Subject: 14048A - Noncompliance Recall
Transmission Shift Cable Adjuster Body Fracture
Customer Letter Added

Models: 2014 Buick Enclave, LaCrosse, Regal, Verano; Chevrolet Cruze, Impala,
Malibu, Traverse; and GMC Acadia

SUBJECT: Transmission Shift Cable Adjuster Body Fracture

3723122

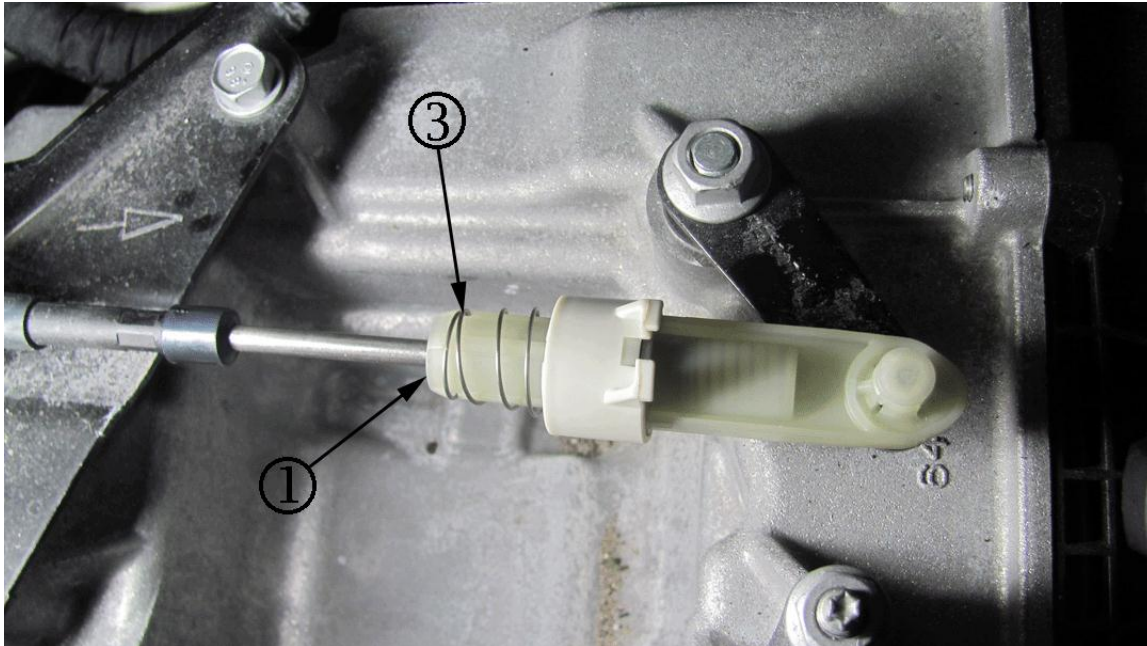
A first design shift cable adjuster body (1) is black and the lock clip is white (2). Refer to the 'A' portion of the photograph. A second design shift cable adjuster body is white and the lock clip is black. Refer to the 'B' portion of the photograph.

2. Determine what design shift cable adjuster body and lock clip are installed on the vehicle.
 - If the vehicle is equipped with a first design shift cable adjuster body and lock clip (A), no further action is required. A first design shift cable adjuster body is black (1) and the lock clip is white (2).
 - If the vehicle is equipped with a second design shift cable adjuster body and lock clip (B), proceed to step 3. A second design shift cable adjuster body is white (1) and the lock clip is black (2).
3. Ensure the transmission range selector lever is in the PARK position.
4. Ensure the transmission shift lever is in the PARK position.

Dealers are to inspect and, if necessary, replace the factory installed white shift cable adjuster body and black lock clip with a black shift cable adjuster body and white lock clip.

3723137

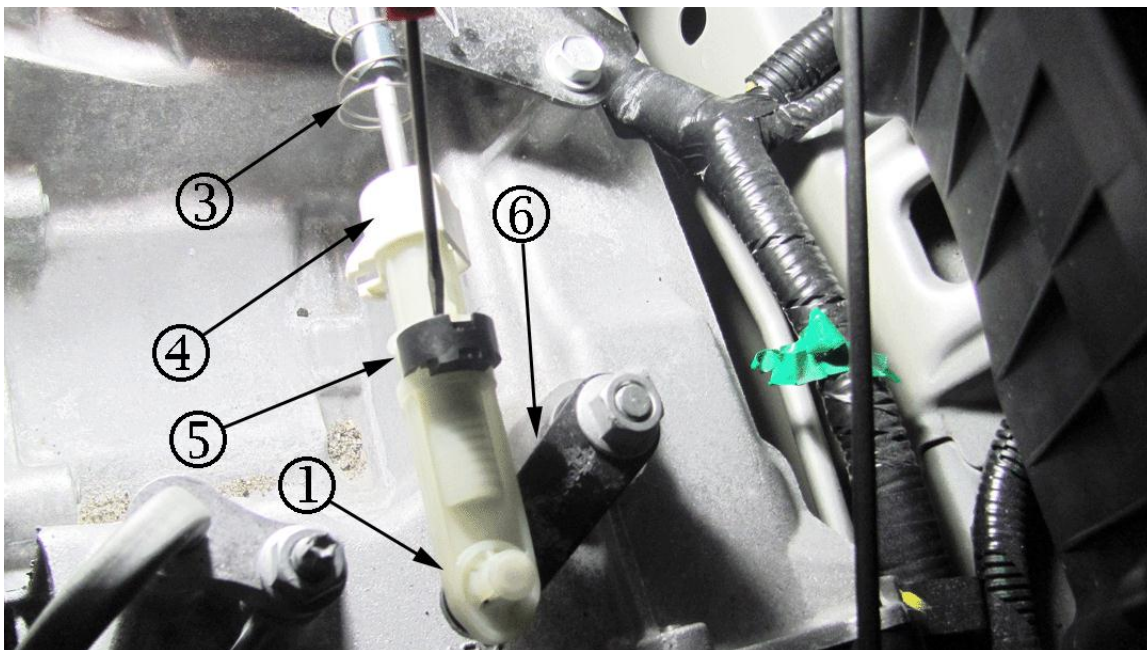
5. Pull the cover spring (3) off the rear portion of the shift cable adjuster body by inserting a flat blade screw driver between the cover spring (3) and shift cable adjuster body (1).

3723129

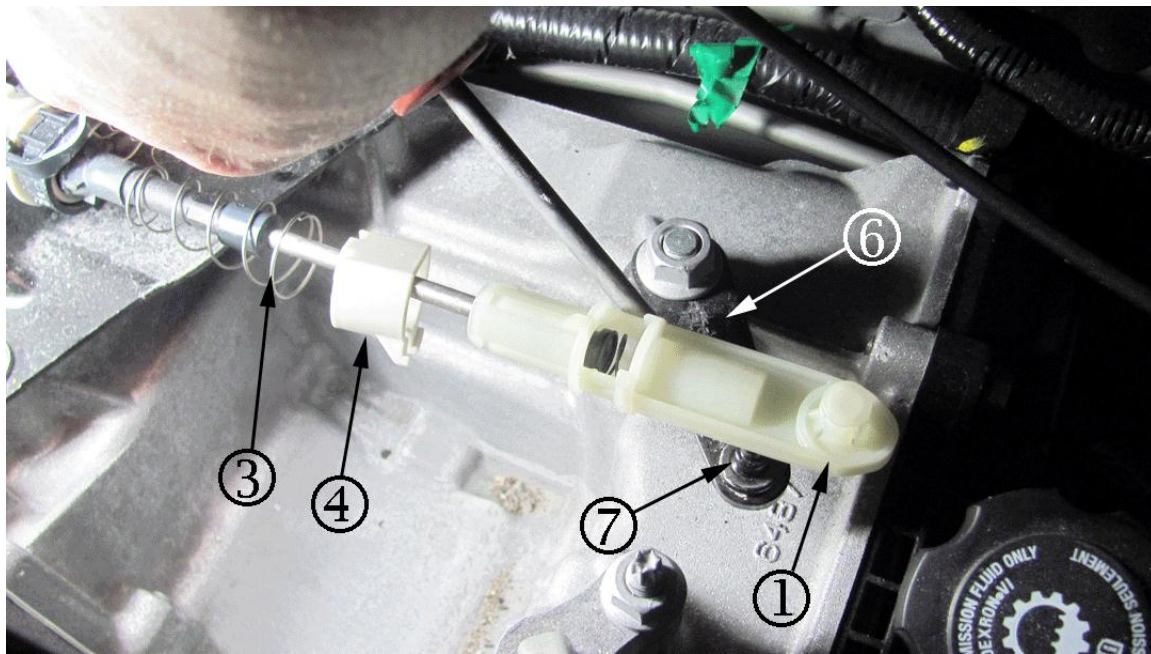
6. Slide the cover spring (3) rearward away from the shift cable adjuster body (1).
7. Slide the secondary cover (4) rearward away from the shift cable adjuster body (1) to fully expose the black lock clip (5).
8. Remove the black lock clip (5) from the shift cable adjuster body using a flat blade screw driver.

3723116

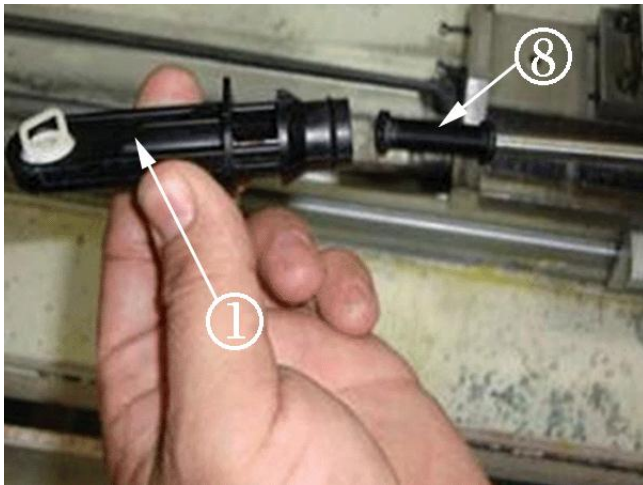
Note: Do NOT reuse the white adjuster body, secondary cover or cover spring. The spring inside the white adjuster body, however, must be transferred to the black adjuster body.

11. Remove the spring inside the white adjuster body and insert it into the new black adjuster body.
